CITY OF AUSTIN
APPLICATION TO BOARD OF ADJUSTMENT
GENERAL VARIANCE/PARKING VARIANCE 0209060816

STREET ADDRESS: 1307 Waller Street

From: McDonald, John
Sent: Tuesday, August 26, 2014 2:25 PM
To: Heldenfels, Leane; Johnson, Christopher [PDRD]
Subject: Approved plans for the home construction
Attachments: APPLICATION.TIF

Prepared By: Sentient Architecture, LLC 702 San Antonio St. Austin, TX 78701 512-444-0777 Issue Date: 6/6/06 Robert Brett Pitt, AIA	PLOT PLAN 1307 Waller St. Austin, TX 78702	Prepared For: El Centro Group, Robert Se 1000 E. 13th Street Austin, TX 78702 512-524-1260
--	---	---

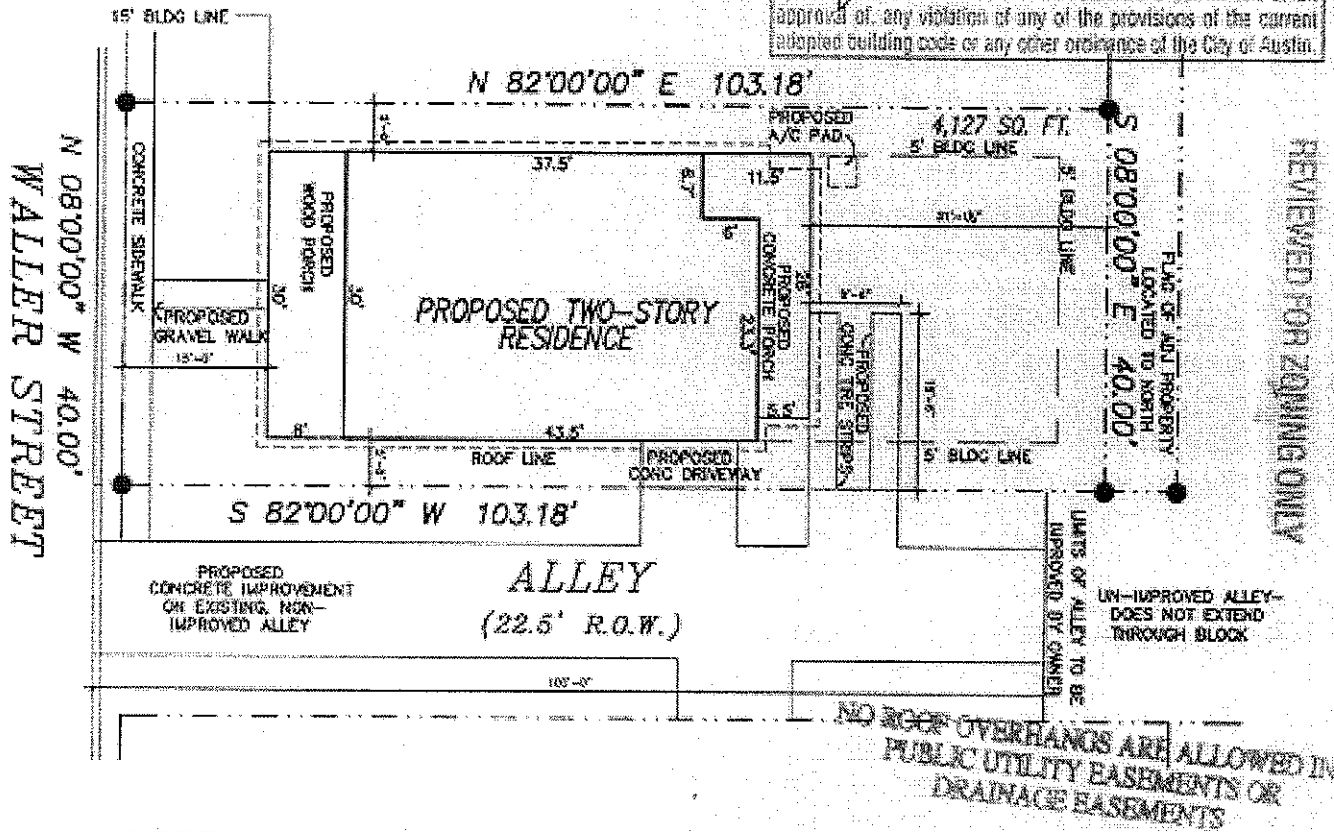
1. As you can see from the plans the home is shown to be honoring both 5' side yard setbacks and the "Telephone/Electric Easement" is not called out or delineated.
2. The "one" off-street parking space does not meet the stall length requirement of 17'.
3. The A/C pad is not shown in the 5' side yard, but it is shown behind the house outside of any setback.

Clearly, the as built survey from March 10, 2014 show deviations from the plans and points out the applicant did not disclose the 5' Electric/Telephone Easement. All easements are required to be shown and it states this in the residential application. Not to mention the fact an applicant is supposed to build what was approved.
